SUBJECT: DuPage Airport  
West Chicago, Illinois  
DuPage County  
Illinois Project Number: DPA-4300  
SBG Project Number: 3-17-SBGP-XX  
Contract No. DU081  
Item No. 05A, 6-10-2016 Letting  
Addendum A

## NOTICE TO PROSPECTIVE BIDDERS

05A  
6-10-2016 LETTING

## CONSTRUCT WEST END PERIMETER ROADWAY

project	88849	contract	DPA-4300
drawing	CS-103		
sheet	of	sheets	
file

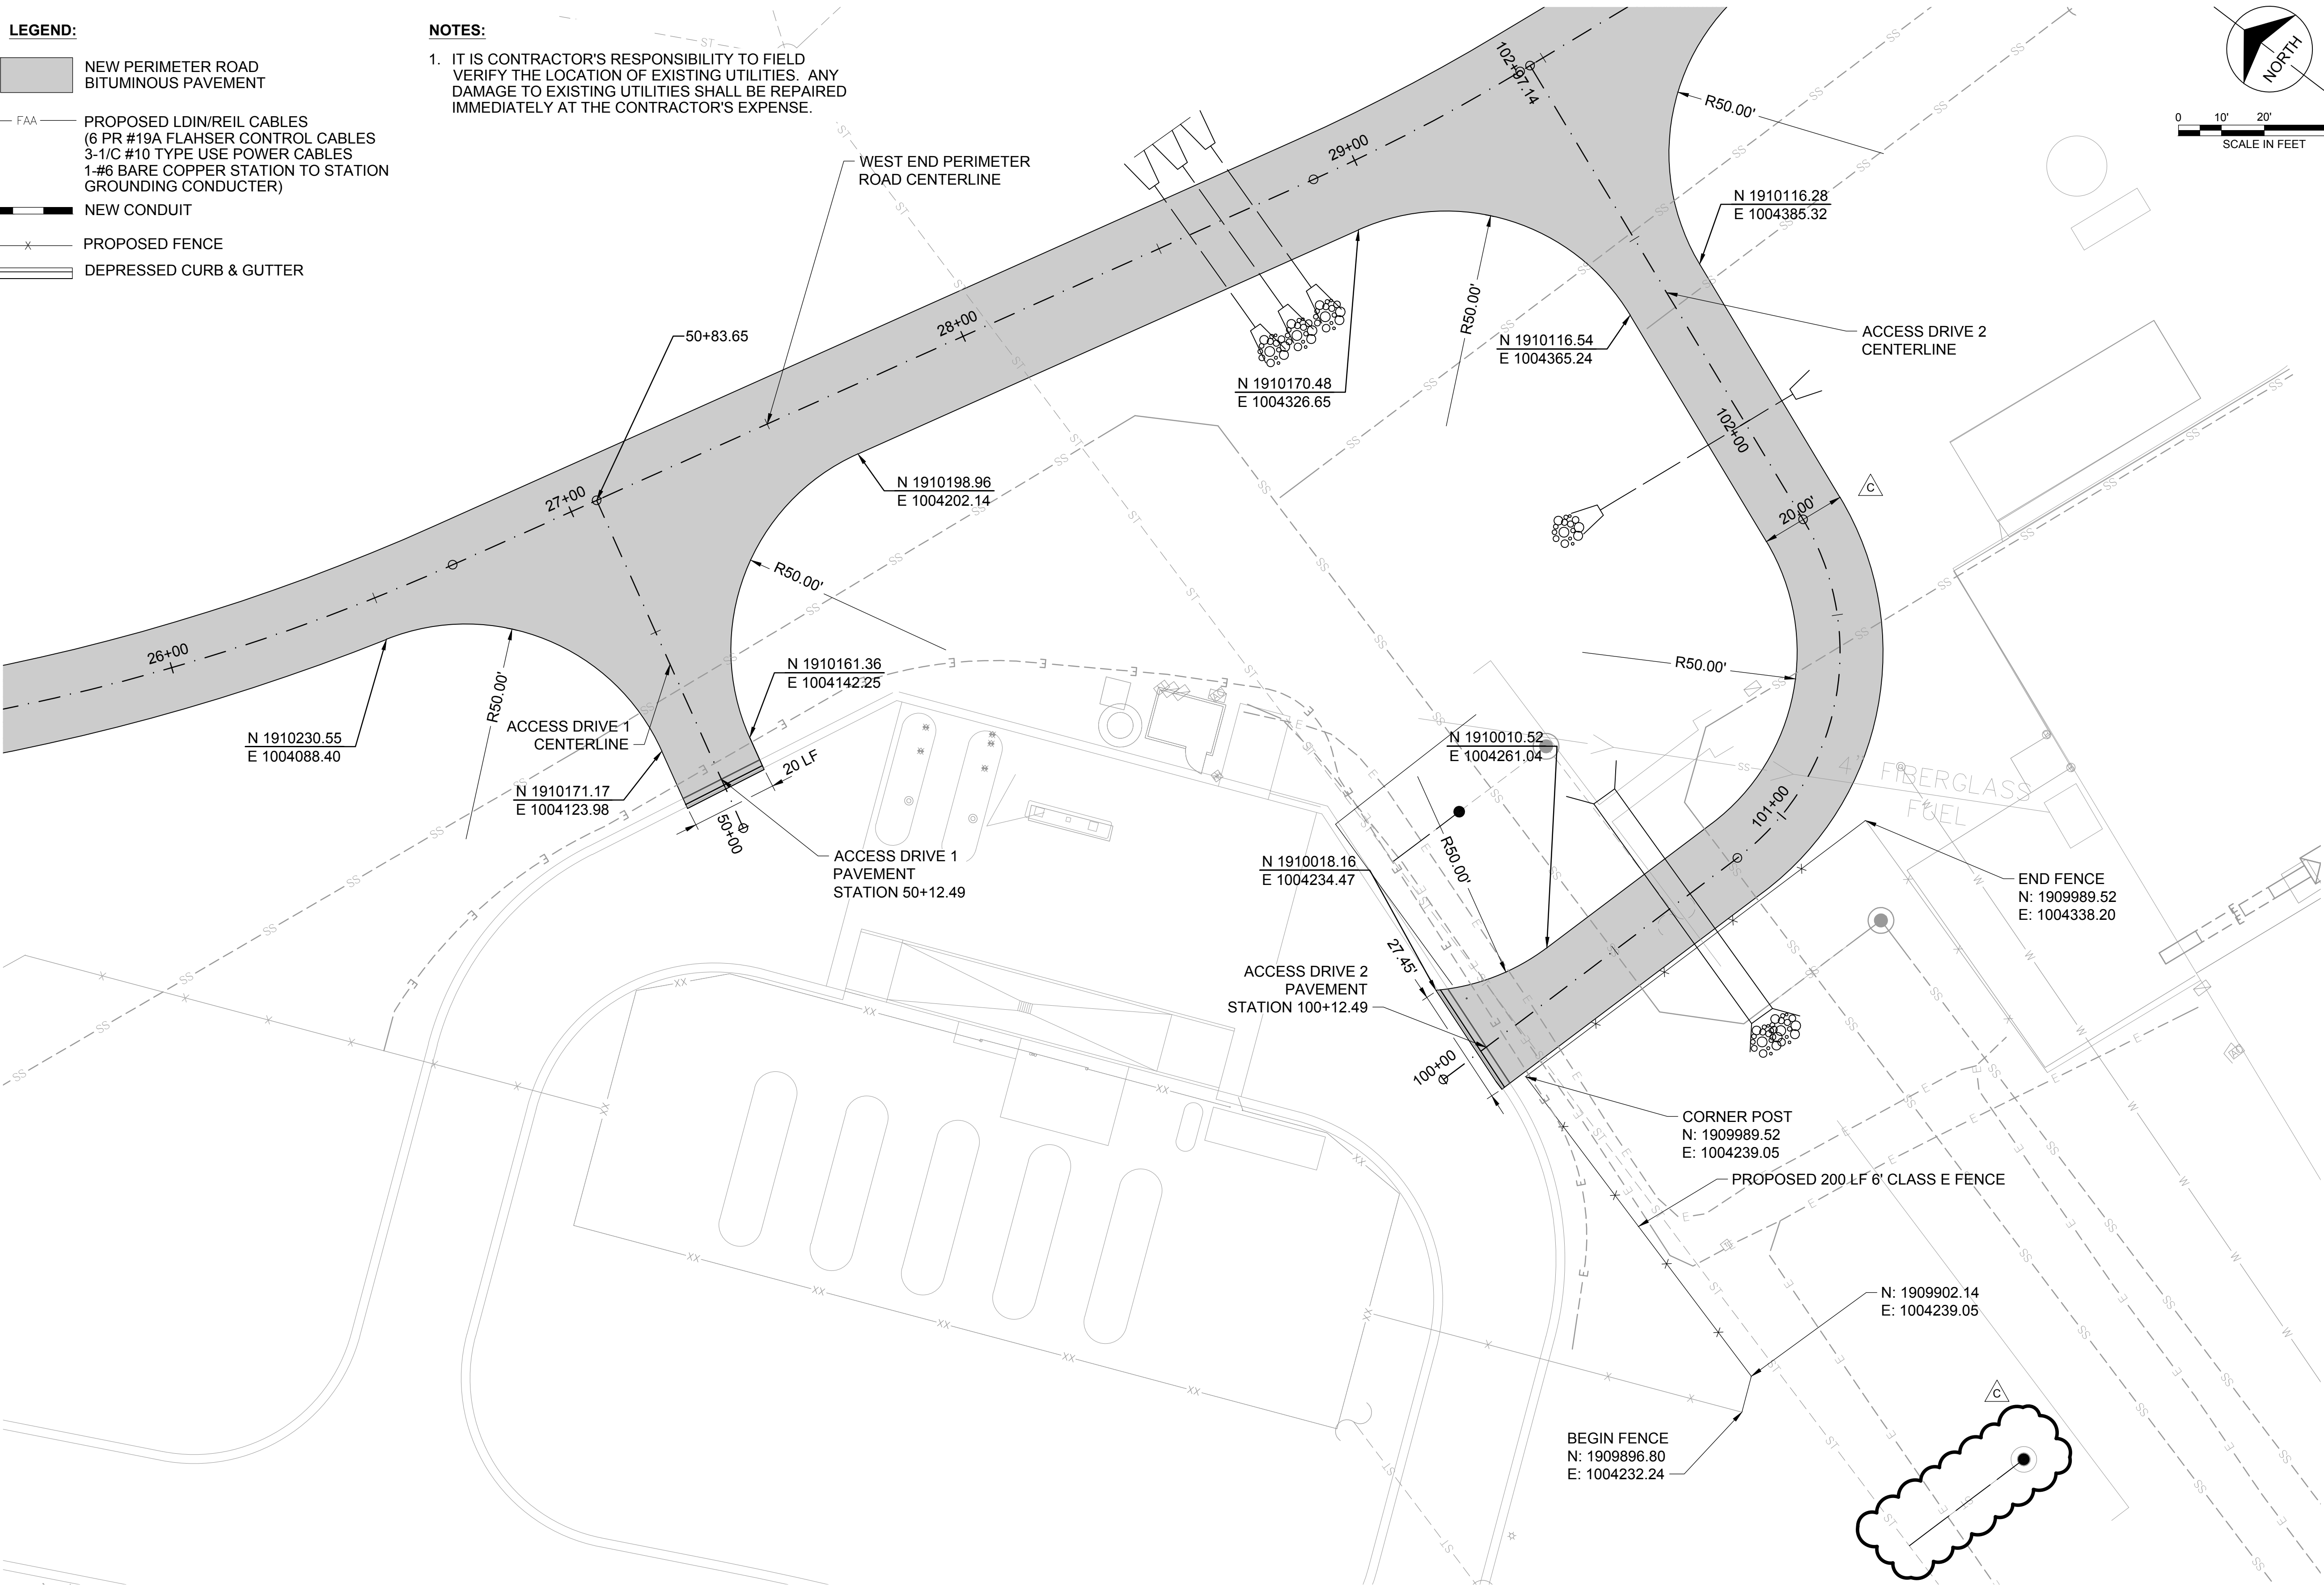
12. CS-102, CS-103, CS-104
  - Revised plan and profile to reflect additional storm sewer
13. CG-101
  - Updated FAA cable and splice box location. Addition of soil borings and topsoil thickness.

project	88849	contract	DPA-4300
drawing	<b>CG-102</b>	rev.	
sheet	of	sheets	
file

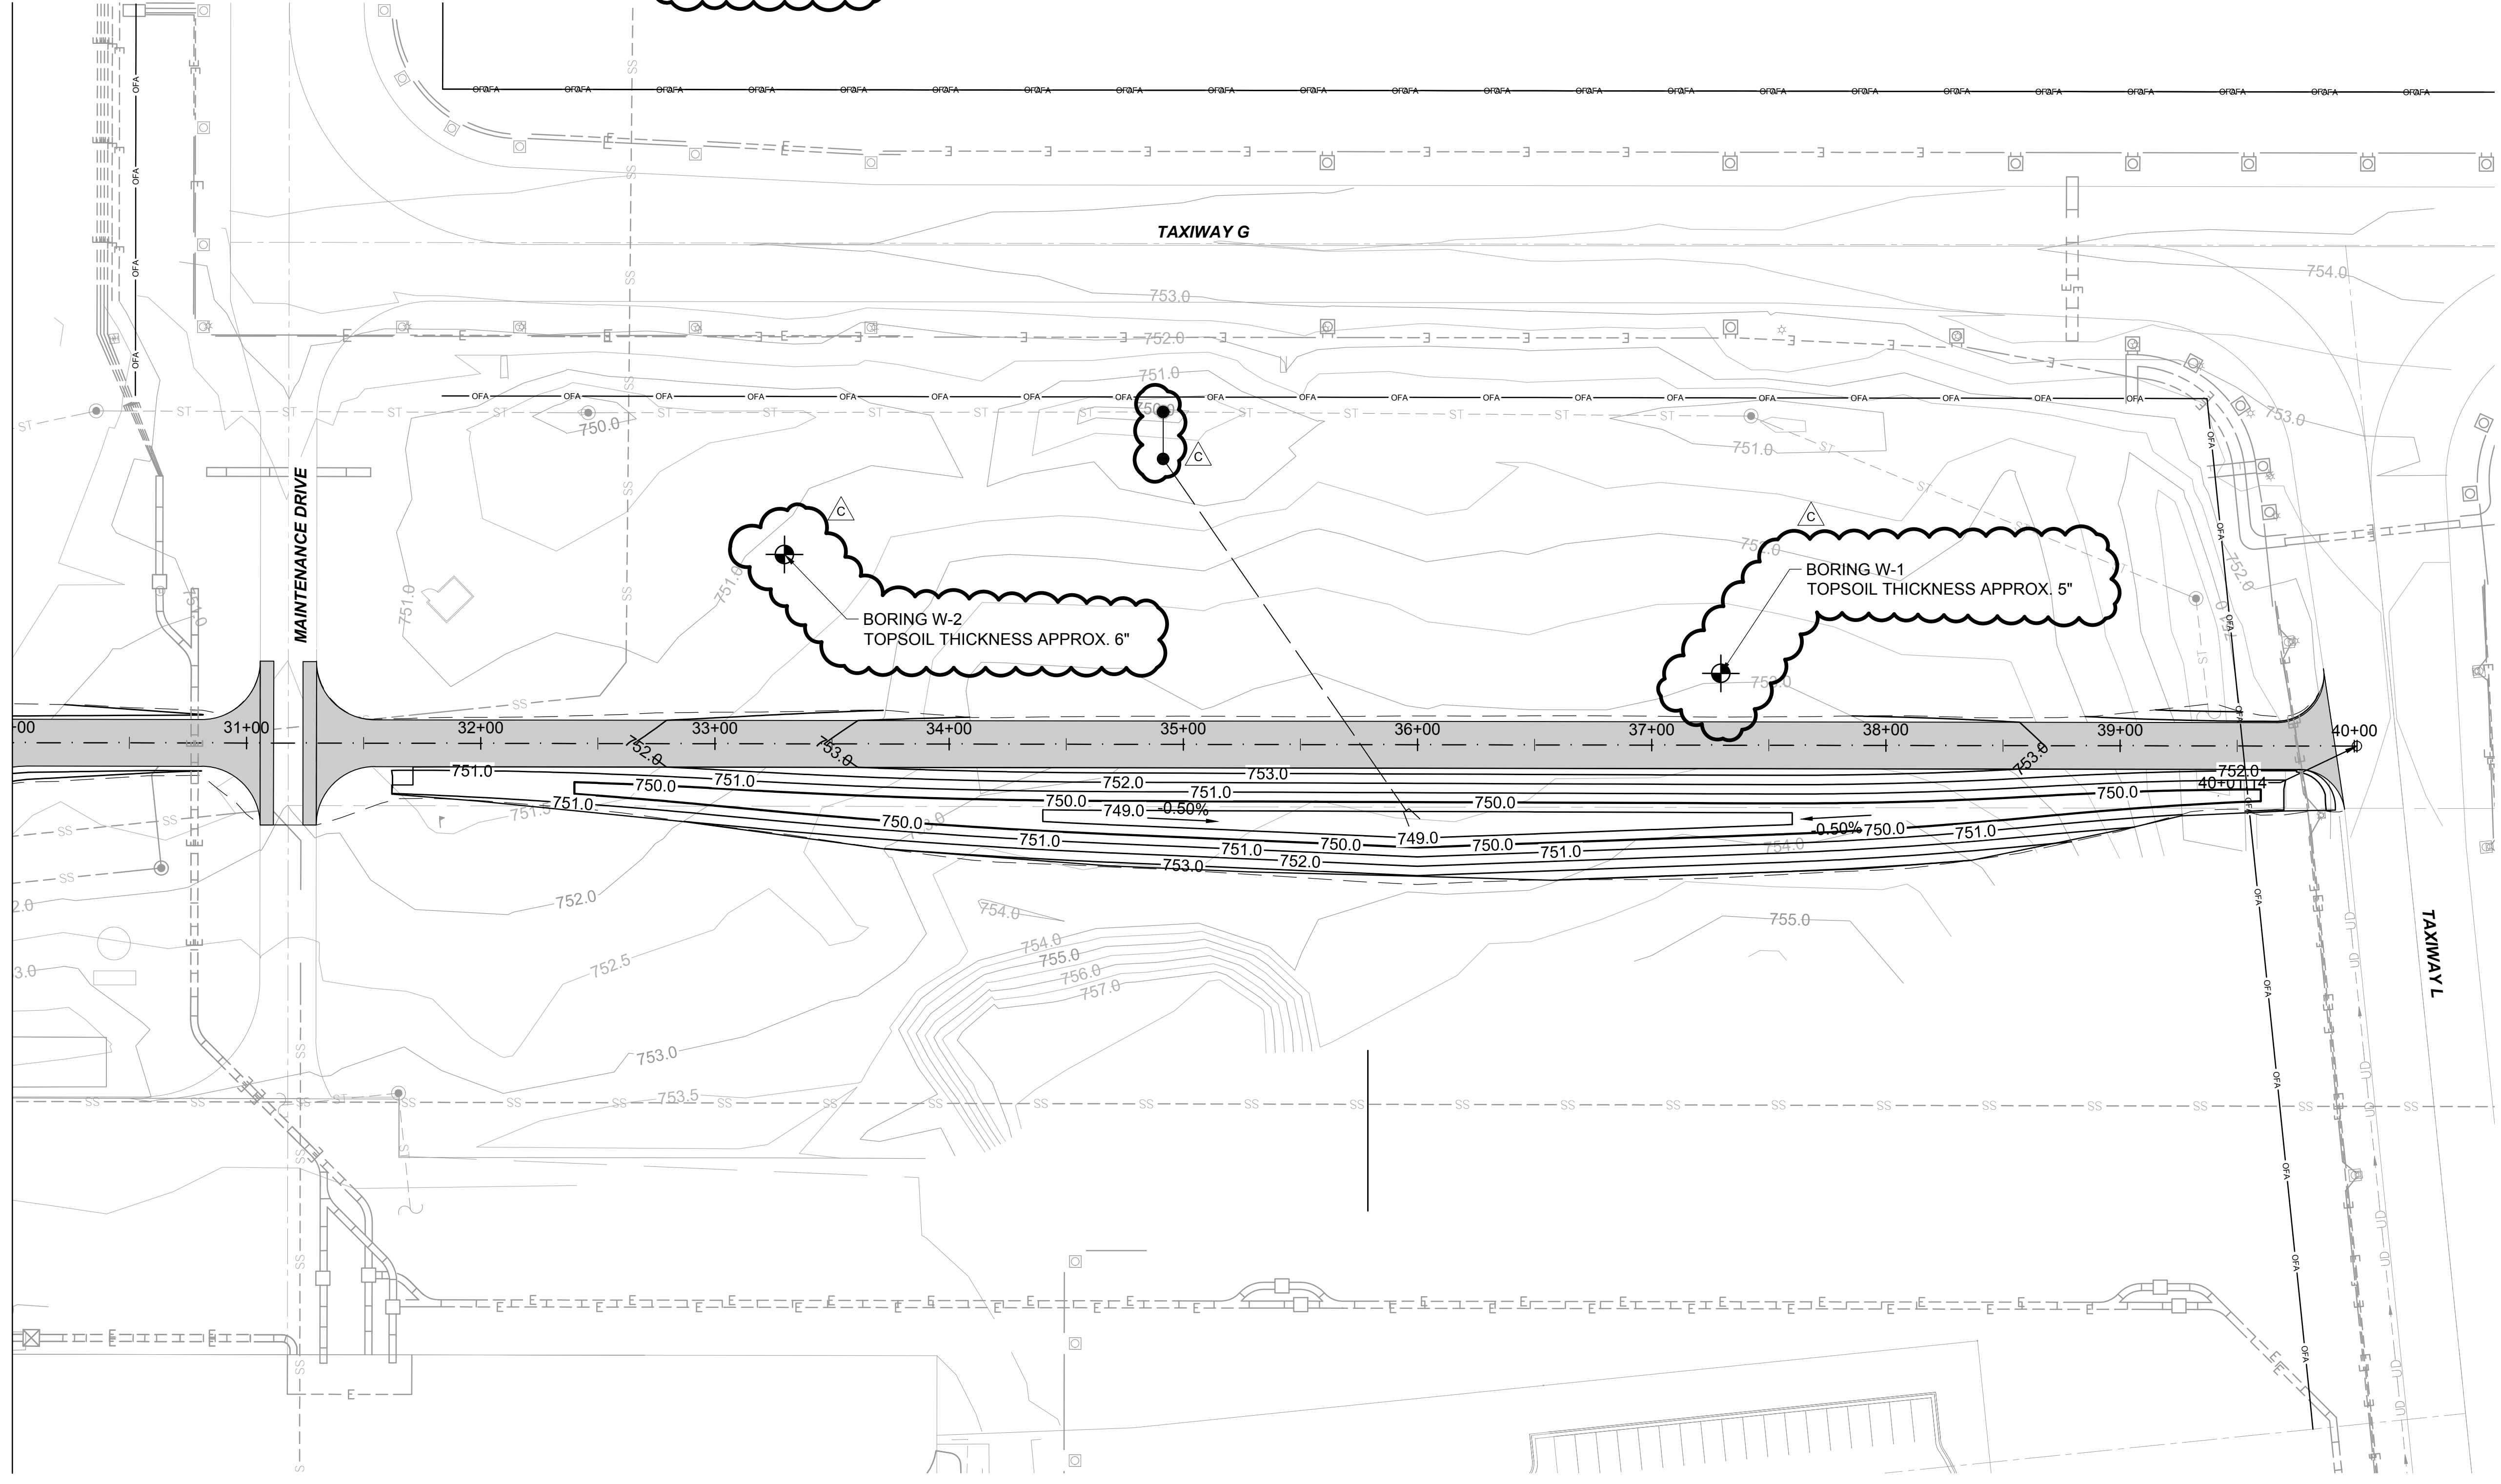
14. CG-102 and CG-103
  - Addition of soil borings and topsoil thickness.
15. CU-101, CU-102 and CU-103
  - Additional storm sewer structures shown and removed seed mix specifications and CU-202 has additional Gravel Construction Access Detail information
